From:
To:
Cc:
Subject: RE: Phase 7 cvc request for initial clarifications [NLP-DMS.FID262297]
Date: 26 October 2018 16:00:14
Attachments:

NYM/2018/0585/CVC – Phase 7 conditions discharge

Request for initial clarifications

Section A
1: 100

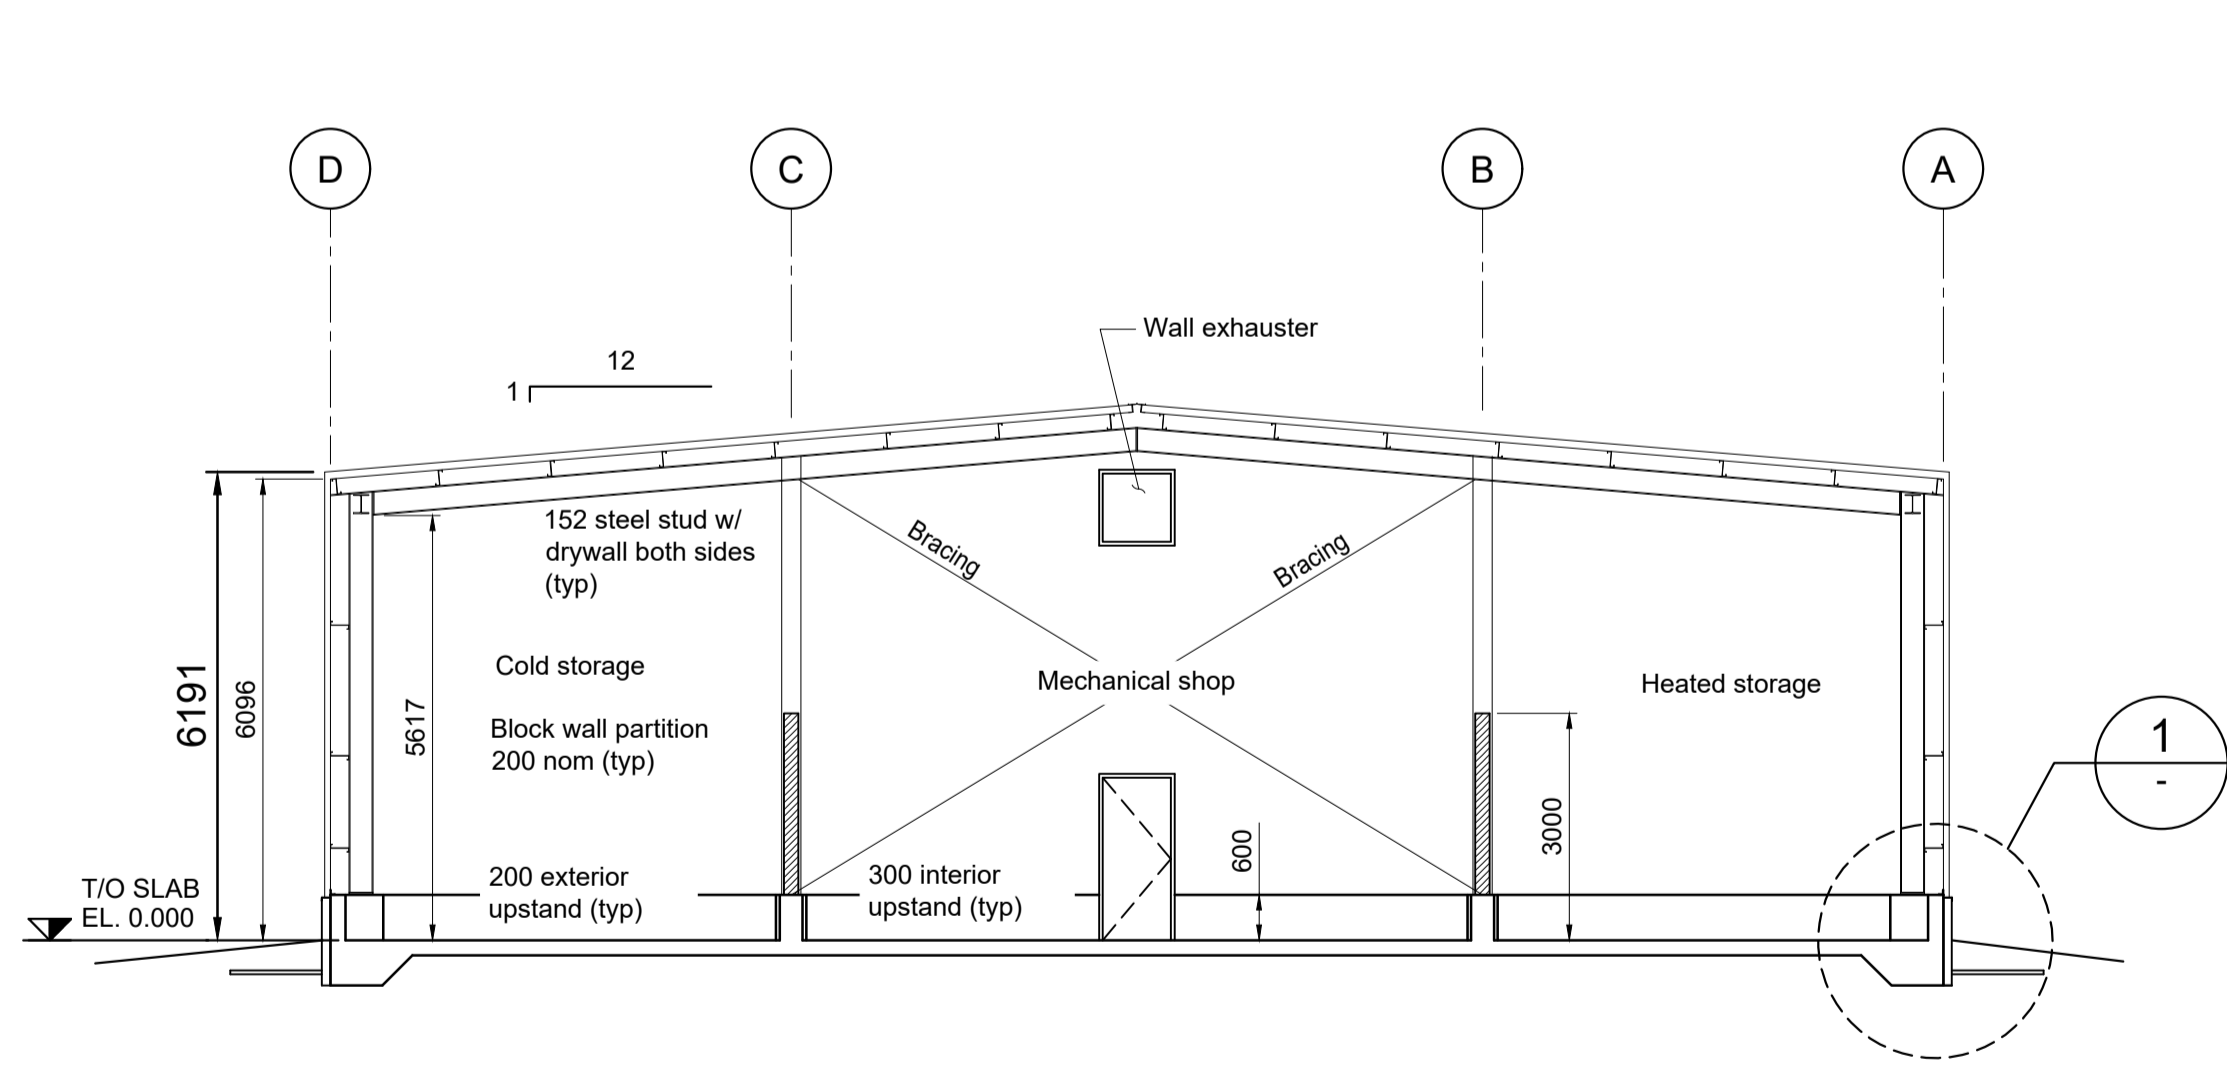
3) It is understood from recent discussion that further illustrative material to demonstrate the appearance of the MTS temporary headframe structure may be available. It would be helpful if this could be provided, together with clarification of any external lighting requirements (other than low level temporary lighting).

The following scaled drawings are attached in response to q. 3:

Building / Structure	Drawing Numbers
MTS Headframe	<ul style="list-style-type: none"> • 40-DMC-WS-1310-AR-31-00002 • 40-DMC-WS-1310-AR-31-00001

External lighting will be limited to low level temporary lighting that accords with the lighting strategy contained within Appendix 11 of the Supplementary ES (June 2017)

Drawing Title: WOODSMITH SHAFT SINKING SET UP Warehouse/Shops Elevations, Section and Detail
 SCALE: 1: 100

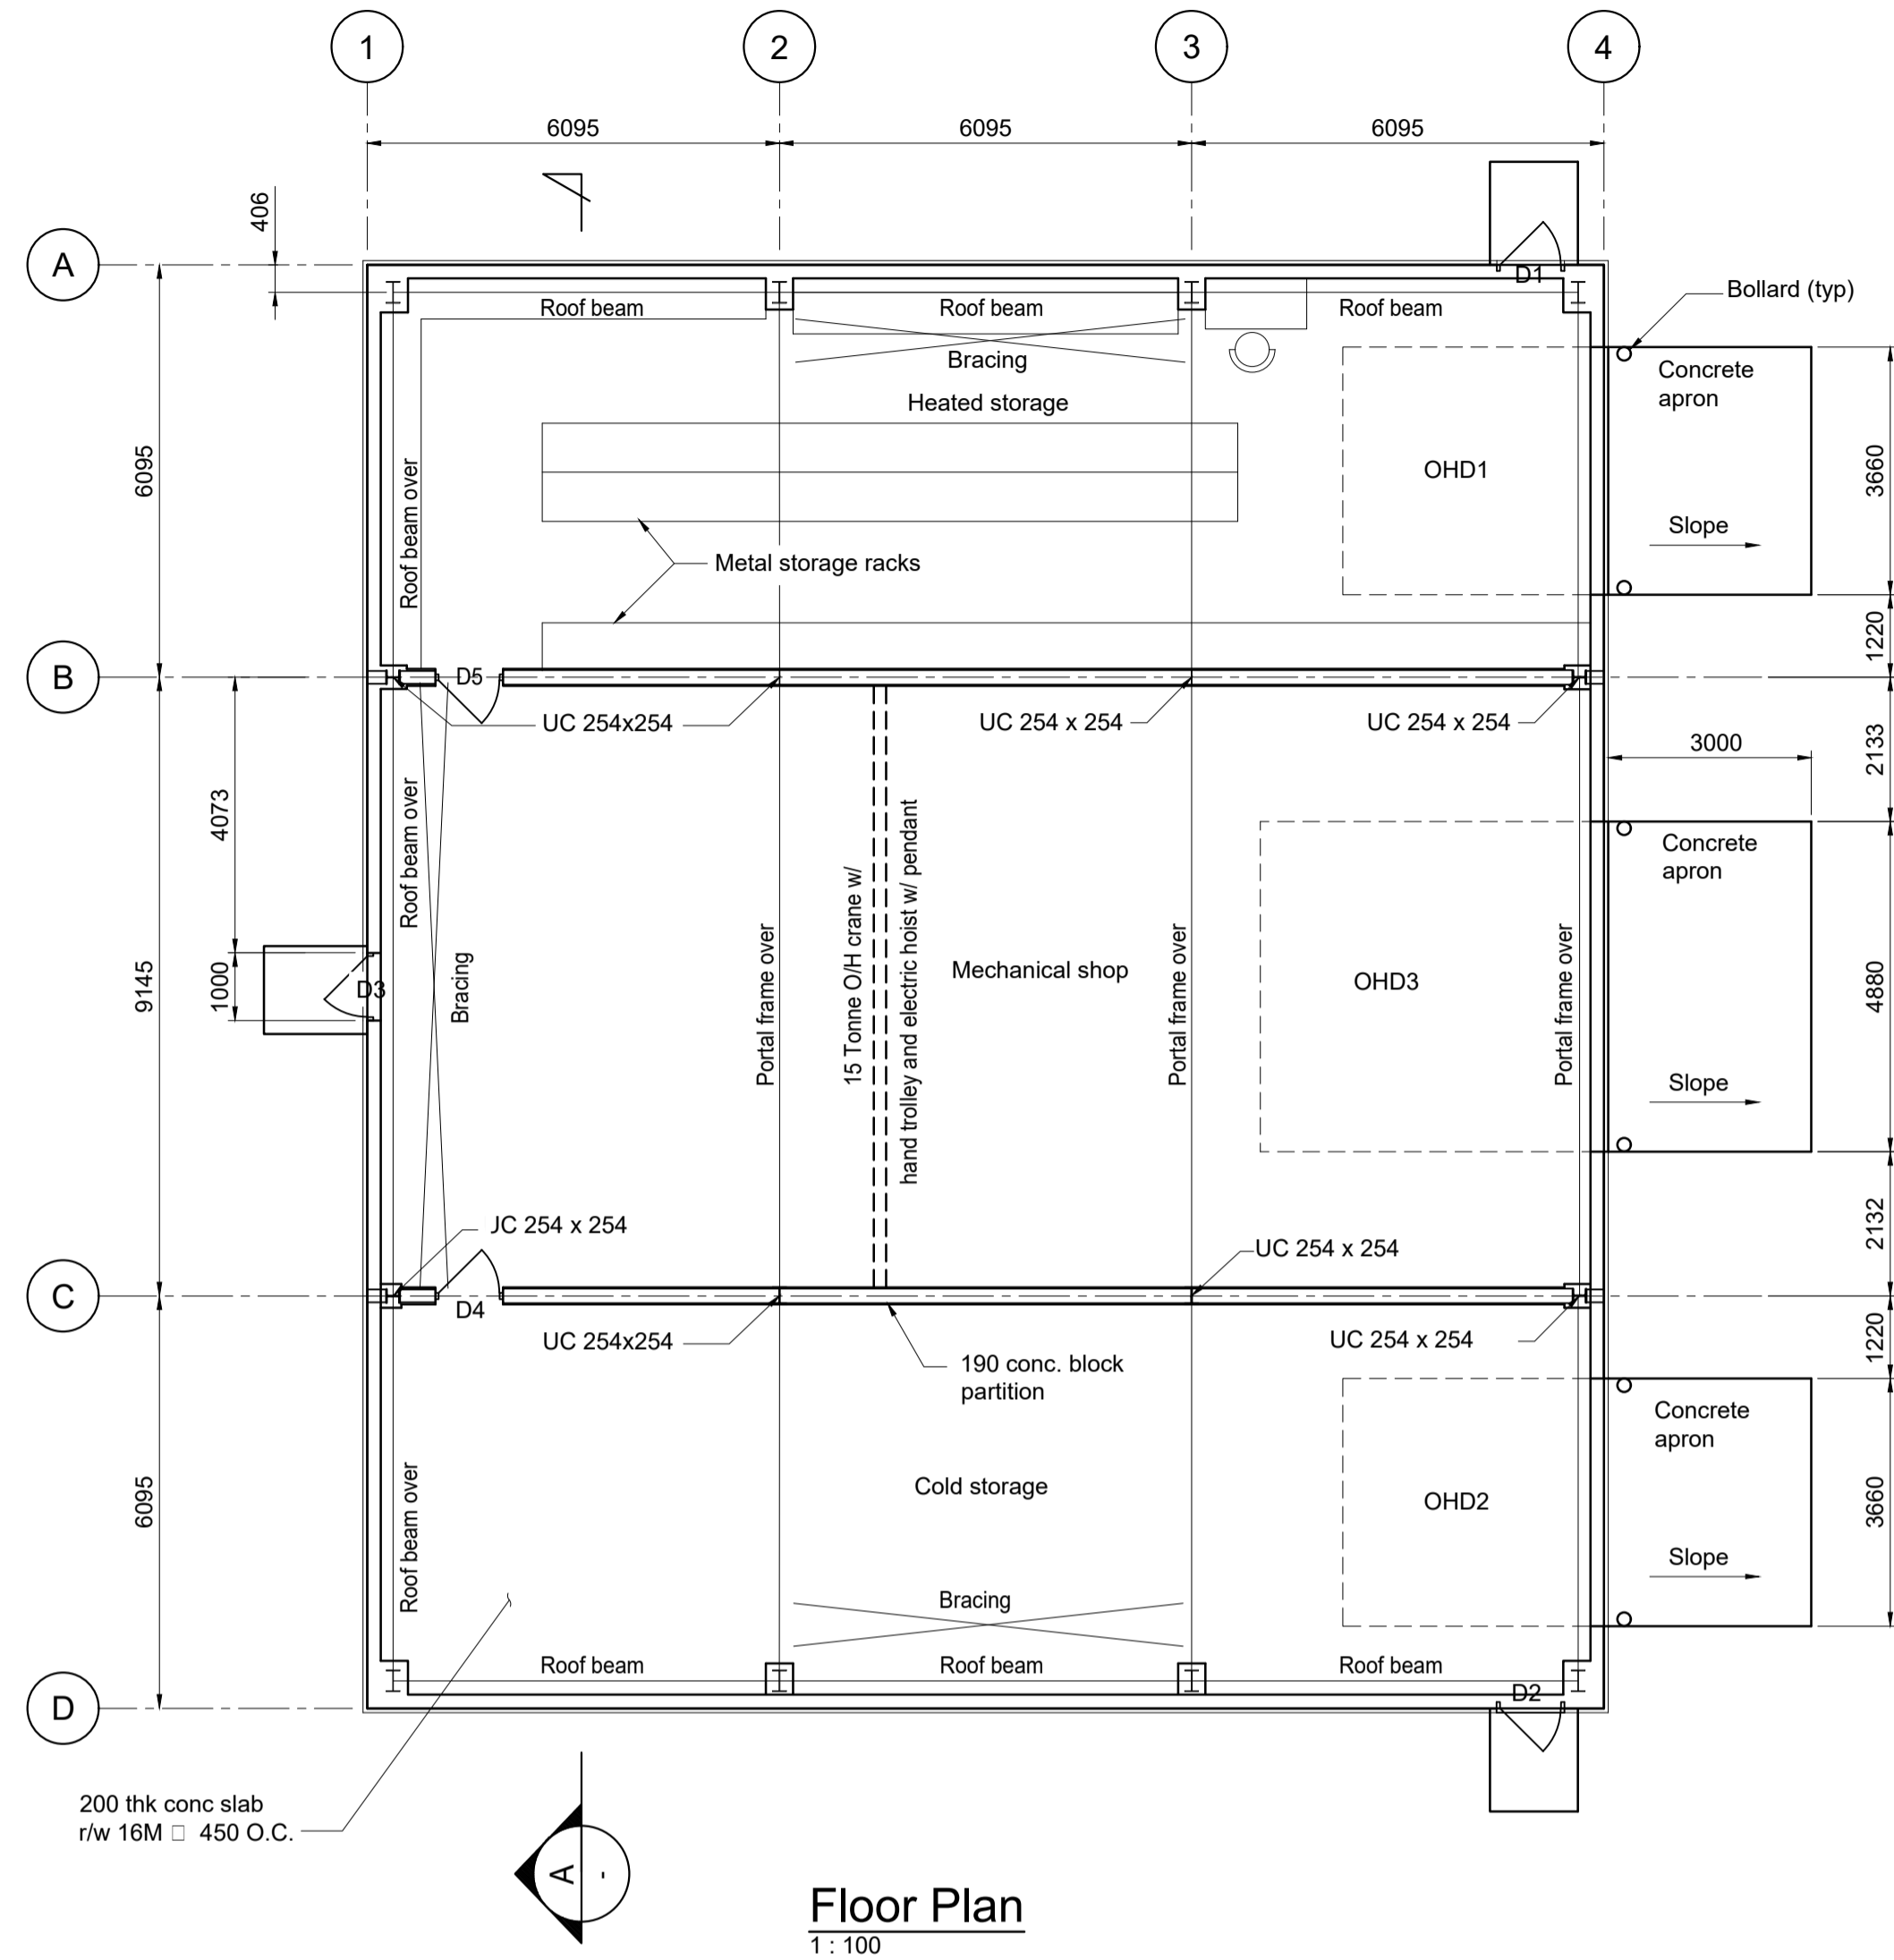
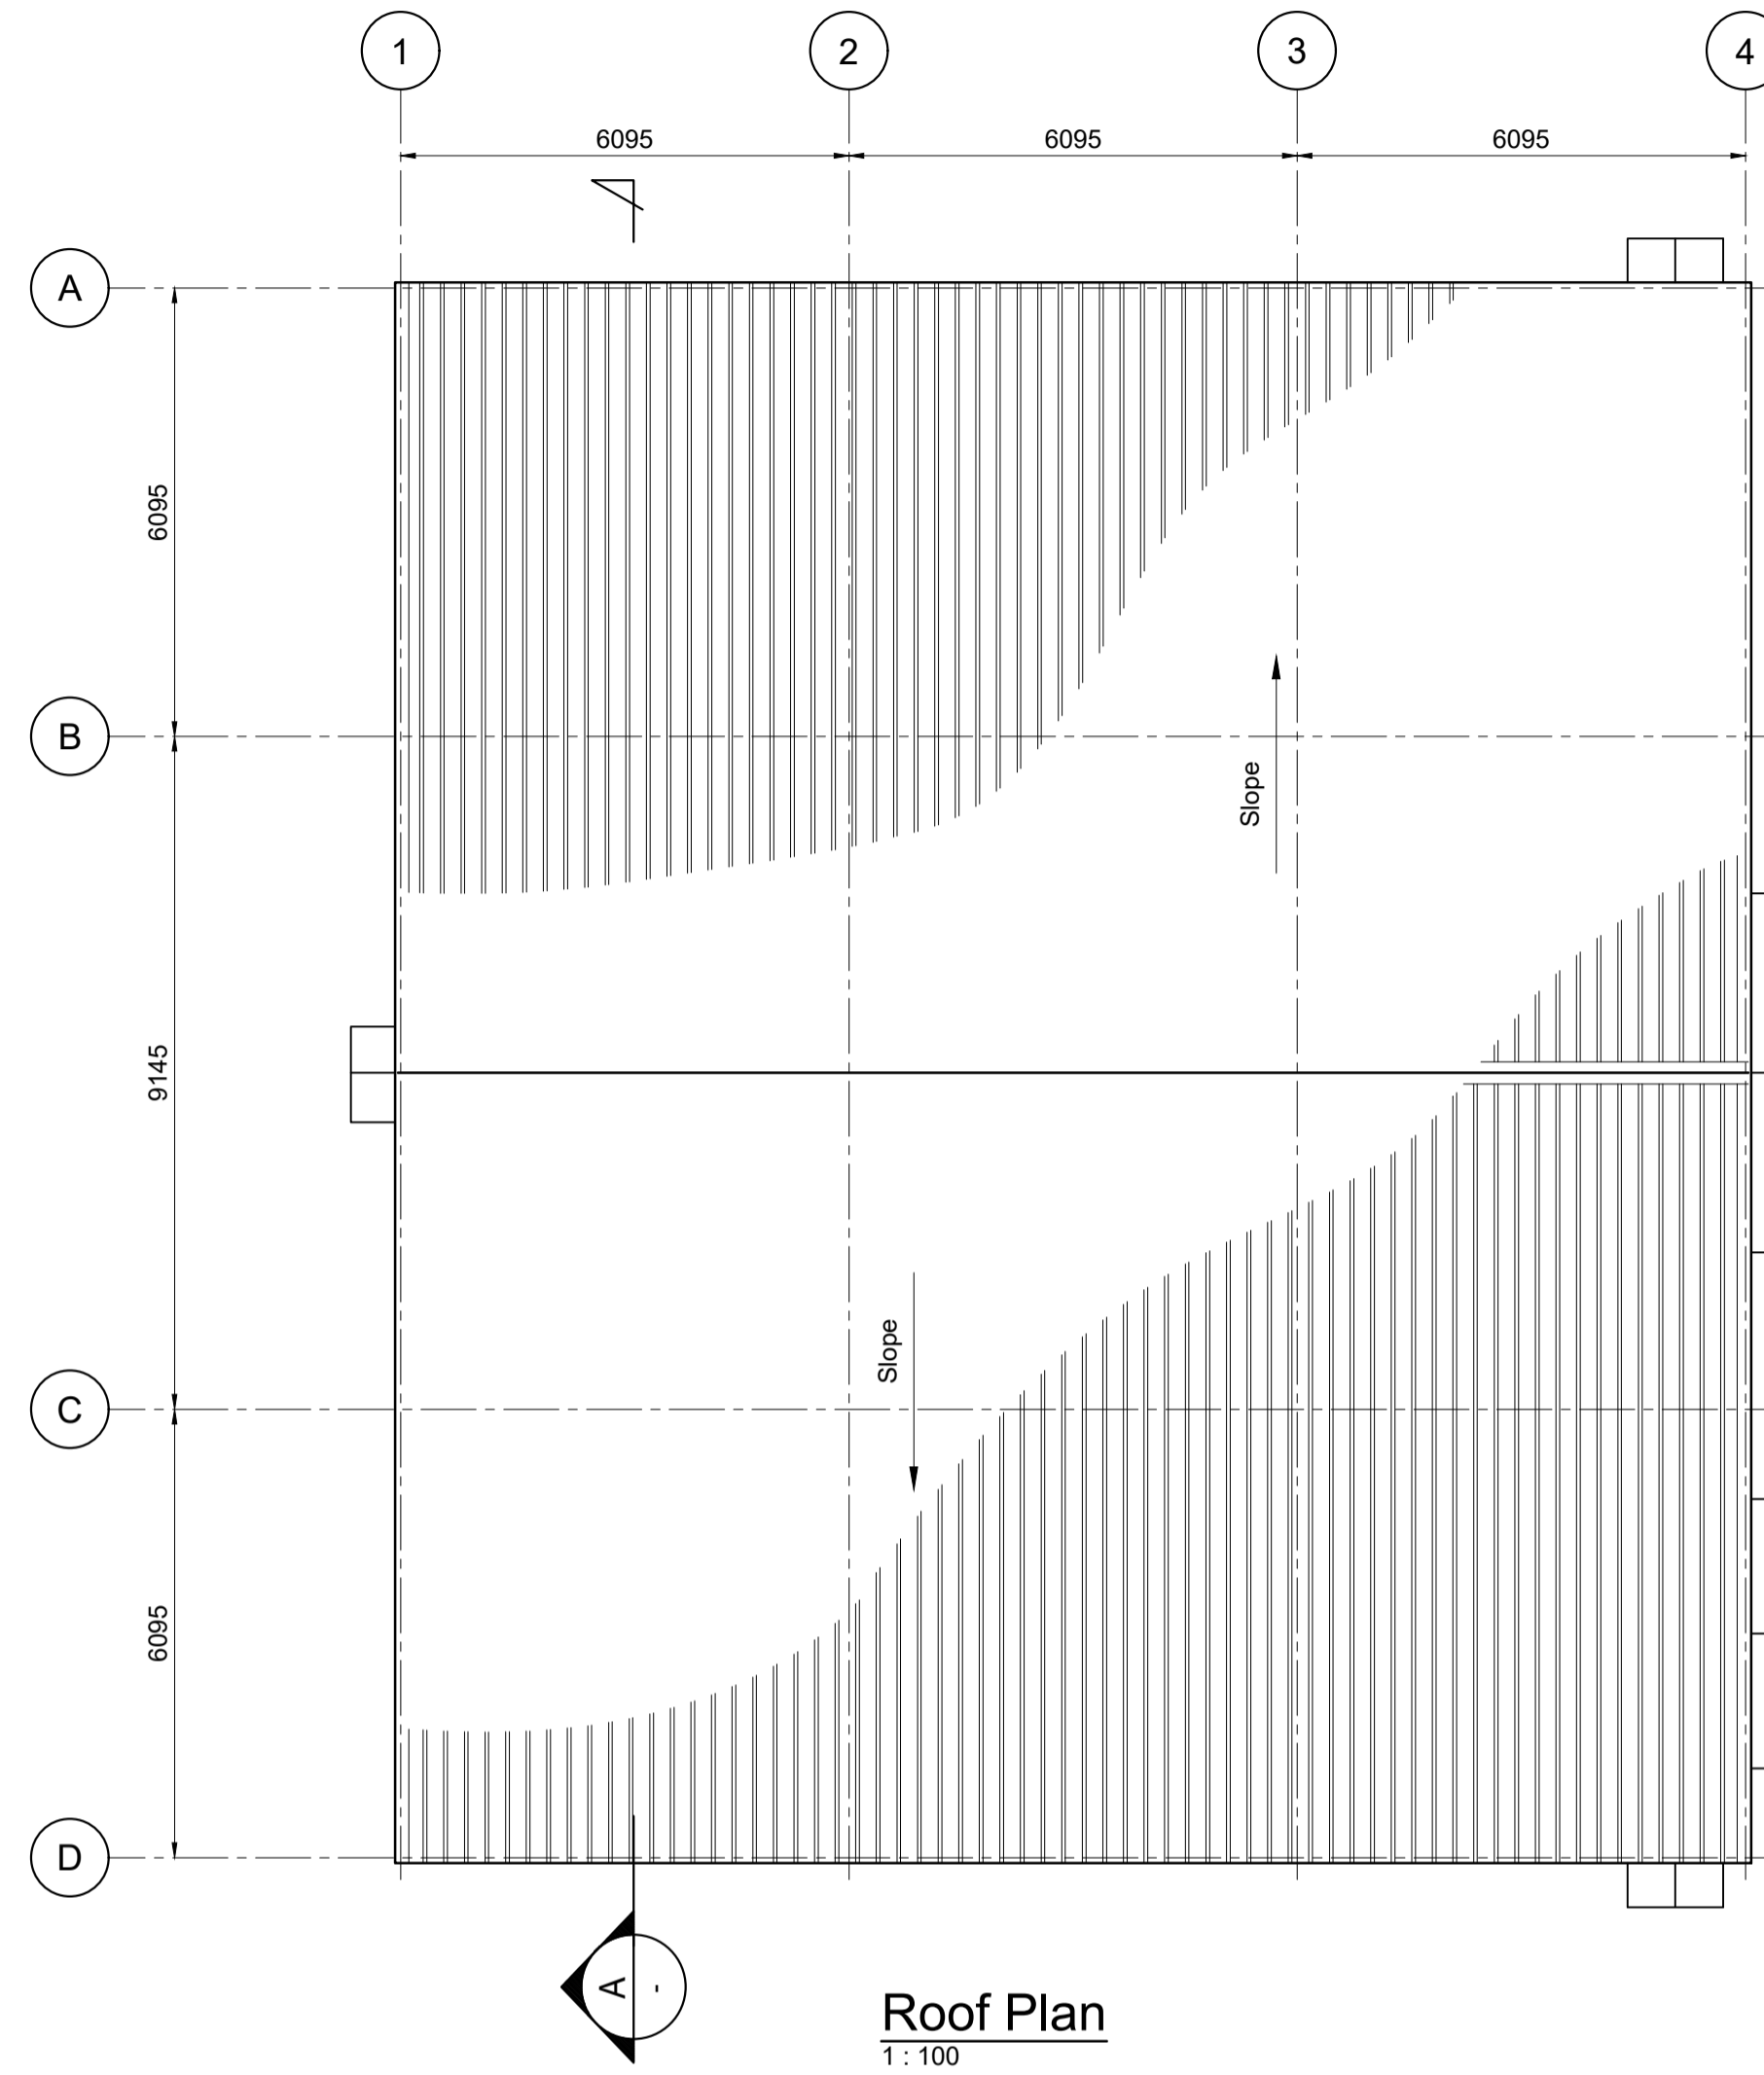
2) Drawing 40-ARI-WS-7100-CI-18-01006 also shows further proposed buildings/structures, including ventilation system structures and temporary workshops/warehouse associated with the service and production shafts. There does not appear to be any information in the submission which indicates the intended size (height) or appearance of these structures. It would be helpful if this could be provided. If it is expected that these structures would be visible to users of the adjacent B1416, it would also be helpful if a representative cross-section to illustrate this could be supplied.

The following scaled drawings are attached in response to q. 2.

Building / Structure	Drawing Numbers
MTS Temporary Workshops / Warehouse	<ul style="list-style-type: none"> • 40-DMC-WS-7219-AR-15-00001 • 40-DMC-WS-7219-GN-18-00001
MTS Ventilation Details	<ul style="list-style-type: none"> • COL-1-0233_MTS Burner Fan 2GAL12-550-550_Rev_C • COL-1-0235_Exhaust Fan_AL14-900_Rev_b
Production Shaft Temporary Winch House	See Construction Method Statement – 3.6.4
Service Shaft Winch House	
Production Shaft and Service Shaft Ventilation Details	These will be the same as those listed under the 'MTS Ventilation Details' above. They will be located within the ventilation system footprints for the Production and Service Shafts, as shown on the submitted Construction Masterplan drawing (ref. 40-ARI-WS-7100-CI-18-01005)
